CITY OF MERIDIAN FINDINGS OF FACT, CONCLUSIONS OF LAW AND DECISION & ORDER

Case No(s). H-2024-0028 Baldcypress Multi-family

SUBJECT: Baldcypress Multi-family CUP

Conditional Use Permit for a multi-family development consisting of 115 residential units on 3.76-acres of land in the C-G zoning district.

A. Site Plan (dated: 7/24/24)

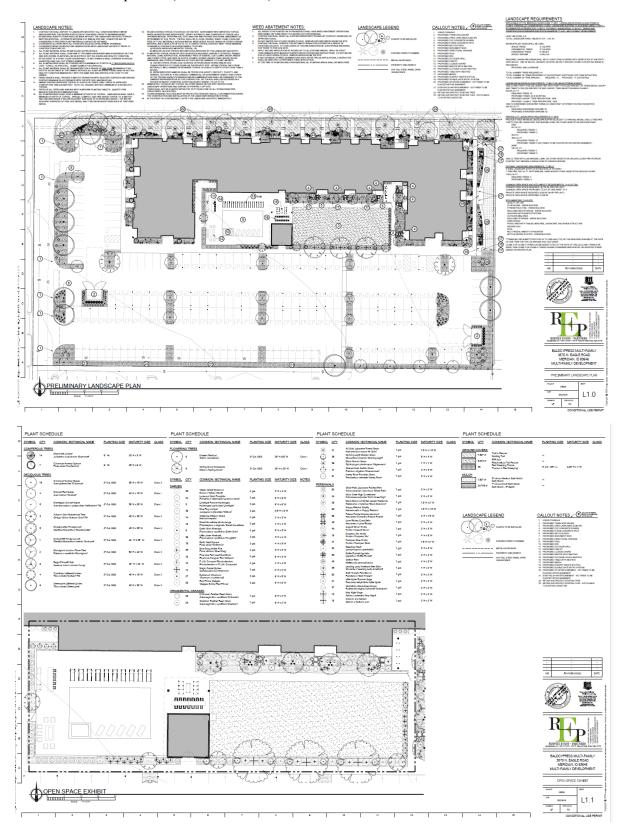
- Per the application narrative, a total of 190 spaces are proposed with 115 of those covered as noted with "CP" on the site plan; the number of bicycle parking spaces are not specified. There are 20 additional on-street parallel parking spaces available along the south side of Baldcypress St. along the northern boundary of the site for overflow parking. The on-site parking meets and exceeds UDC standards by one (1) space; the additional on-street spaces will provide overflow parking if needed.

Parking: Off-street parking is required in accord with the standards listed in UDC Table 11-3C-6 as discussed above in #B.6. Per Fire code requirements, structures over 2-stories in height are required to have 26-foot wide drive aisles closest to the building; the plans should be revised accordingly.

When a bumper overhangs onto a sidewalk or landscape area, the parking stall dimensions may be reduced 2' in length if 2' is added to the width of the sidewalk or landscaped area planted in groundcover, per UDC 11-3C-5B.4. Alternatively, wheel restraints may be provided to prevent vehicle overhang per UDC 11-3C-5B.3. There is parking along the west and south sides of the building and along the southern and eastern perimeter boundaries of the site that don't what wheel restraints to prevent vehicle overhang – Staff recommends wheel restraints are provided or an additional 2' is added to the abutting sidewalk or perimeter buffer to accommodate vehicle overhang in accord with UDC standards.

- e. Include a detail of the bicycle rack that demonstrates compliance with the required standards in UDC 11-3C-5C.
 - f. Internal drive aisles shall be widened to 26-feet around the building in accord with Fire code requirements.

- g. Wheel restraints shall be depicted in parking spaces that abut sidewalks or perimeter buffers; or, an additional 2-feet shall be added to the abutting sidewalks and perimeter buffers to accommodate vehicle overhang in accord with UDC 11-3C-5B.3-4.

B. Landscape Plan (date: 6/24/2024)

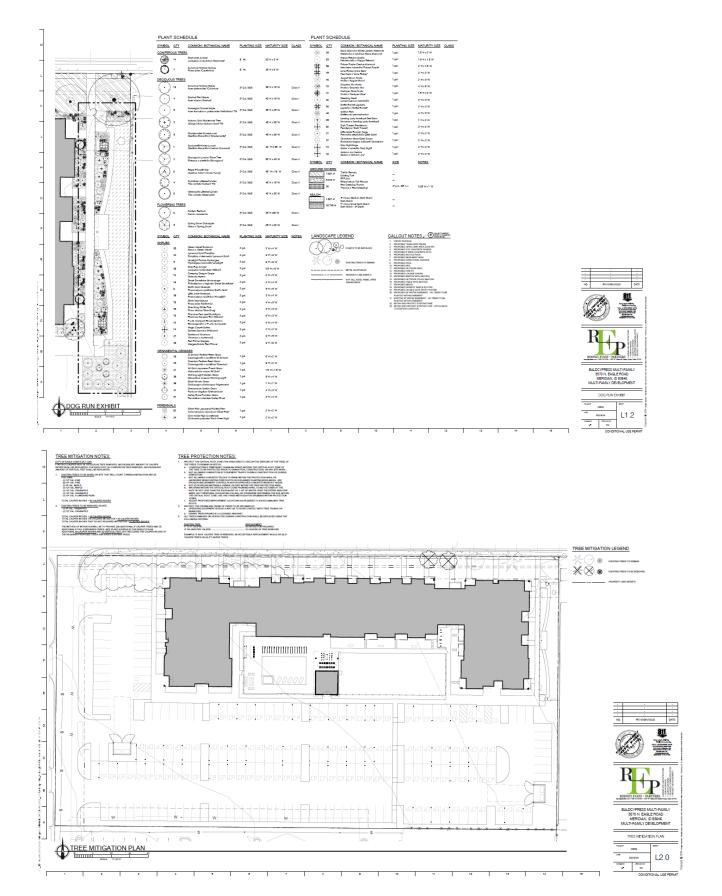
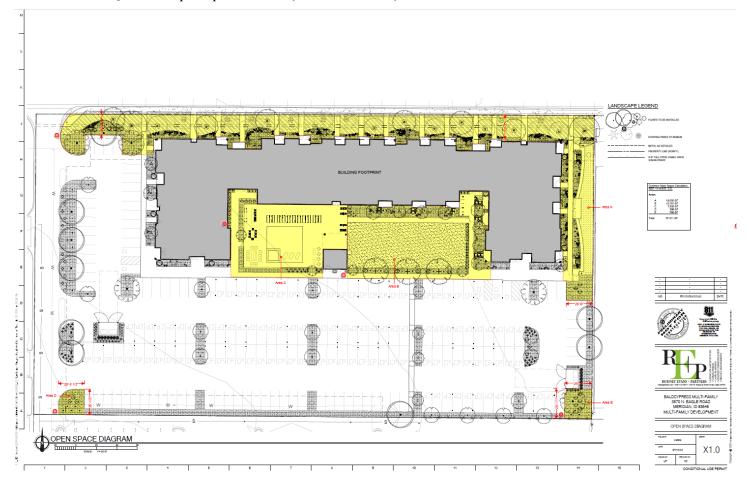
The landscape plan depicts landscape areas at least 3' wide and evergreen shrubs every three (3) linear feet and ground cover plants in the remainder of the landscaped area; the species, mature size of the plantings and tree class should be included in the Landscape Legend on the plan submitted with the Certificate of Zoning Compliance application that demonstrates compliance with this standard and those in UDC 11-3B.

Because this site is surrounded by commercial uses, Staff recommends dense landscaping is provided in perimeter buffers along the west, south and east boundaries of the parking area in accord with the standards in UDC 11-3B-9C (trees aren't allowed within the water easement but shrubs should be allowed).

- d. The species, mature size of the plantings and tree class should be included in the Landscape Legend on the landscape plan demonstrating compliance with the minimum UDC standards for such in UDC 11-3B and 11-4-3-27.

- i. Depict dense landscaping in perimeter buffers along the west, south and east boundaries of the parking area in accord with the standards in UDC 11-3B-9C (trees aren't allowed within the water easement but shrubs should be allowed).

C. Qualified Open Space Exhibit (dated: 7/15/2024)

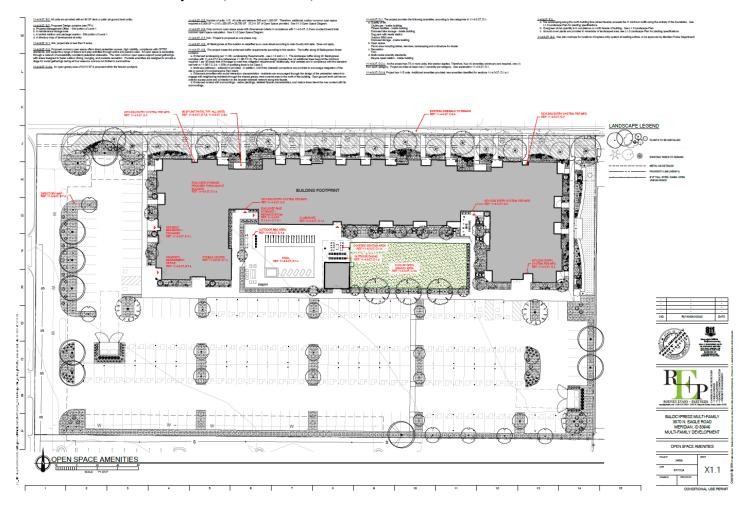
The submitted plans depict one (1) 5,010 s.f. common grassy area on the south side of the building and a linear open space area on the east side of the building for a dog run. The Commission should determine if this is commensurate with the size of the proposed development or if additional area should be required.

A total of 37,311 square feet (or 0.86-acre) is proposed, which exceeds the minimum standards. Open space areas consist of the street buffer along Baldcypress St., a collector street, linear open space where the dog run is proposed along the east side of the building, two (2) landscaped areas along the southern boundary of the site at the east and west ends, and the open grassy area and outdoor amenity area. In order to count the buffer along the collector street, it has to meet the enhanced buffer requirements in UDC 11-4-3-27C.9 and 11-3B-7C.3f; the landscape plan submitted with the Certificate of Zoning Compliance application should be revised to reflect compliance with these standards.

The common open space exhibit depicts the street buffer along W. Baldcypress St., a collector street, as part of the required open space. Therefore, the buffer shall comply with the enhanced

- h. The street buffer along W. Baldcypress St. shall comply with the enhanced buffer requirements listed in UDC 11-4-3-27C.9 and 11-3B-7C.3f, except for a multi-use pathway, which is not required.
